Discussion of “Evaluation of Methods for Localized Differential Foundation Movement in Post-Tensioned Concrete Foundations”

John Bryant, Ph.D., P.G., P.E.¹; Tony Childress, P.E., S.E.²; Brian Eubanks, MSCE, P.E.³; Don Illingworth, P.E.⁴; Derrick Lee, P.E.⁵; Dean Read, MSCE, P.E.⁶; and David Sparks, P.E., S.E.⁷

Figure 1. Localized Deflection Ratio from Guidelines for the Evaluation and Repair of Residential Foundations Ver. 3 (Source: TX ASCE).

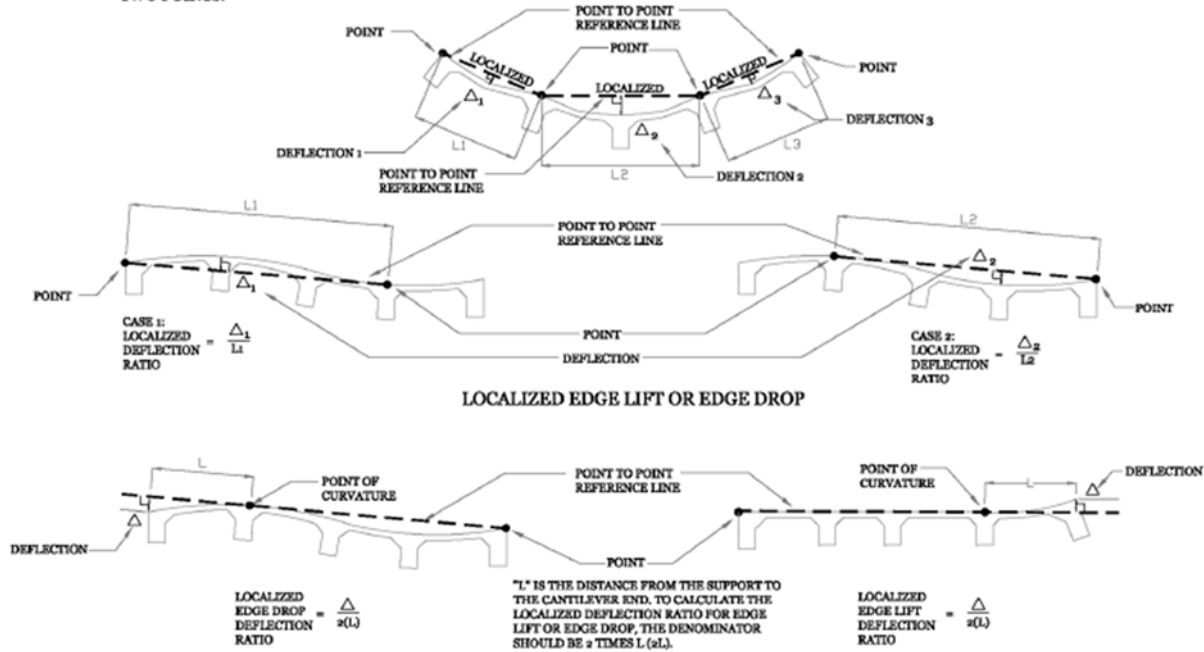
The authors describe the cross section in the original paper as a cantilever deflection. The discussers believe this is an inaccurate assumption for multiple reasons. One, there is no deflection/curvature or bending consistent with a cantilever within the authors' section. Two, the authors only use two points to calculate assumed deflection. By using only two points, the authors define global or planar (rigid body) tilt or an average slope, which is not deflection/curvature. The discussers believe that the use of the two points of measurement for a cantilever ignores fundamental engineering principles. To have a cantilever member, there must be fixity or a back-span or point of reference also known as a neutral reference or original shape. This would include knowing the rotation in degrees at the point of inflection (this point defines the point of fixity of the cantilever). To establish the cantilever back-span, one must demonstrate little or no foundation movement in that area via a distress inventory and analysis. Otherwise, if distress is present in the assumed back span, it indicates a cantilever condition does not exist, as there is not demonstrated fixity.

The authors' two-point deflection measurement is really three-point deflection measurement with a presumed third point based on an assumed original relatively level condition. There is no basis provided in the original paper to establish the presence of the back-span. As previously discussed, the assumed level condition is not reasonable. Fig. 1 contains examples of the proper method of evaluating a cantilever deflection. L as the length for the evaluation of the assumed cantilever section is used in the original paper. To properly evaluate a cantilever deflection, $2L$ should be used for the length.

Proper mathematical and engineering principles as well as the building code dictate the use of $2L$ for the length of a cantilever when calculating deflection for a cantilever. The IBC, International Residential Code (IRC), ASCE 7, and the ASCE Texas Section (Guidelines for the Evaluation of Repair of Residential Foundations Ver. 3) all clearly state $2L$ is to be used in the evaluation of cantilever deflections. It is also noteworthy that the PTI DC10.8-18 Guide for Performance Evaluation of SOG Foundations does not prohibit cantilever analysis, but rather illustrates an example of incorrect cantilever analysis when there is no evidence of a back-span (Fig. 2). Therefore, the analysis method deviates from model building codes as well as basic mechanics in their method of evaluating an assumed cantilever deflection.
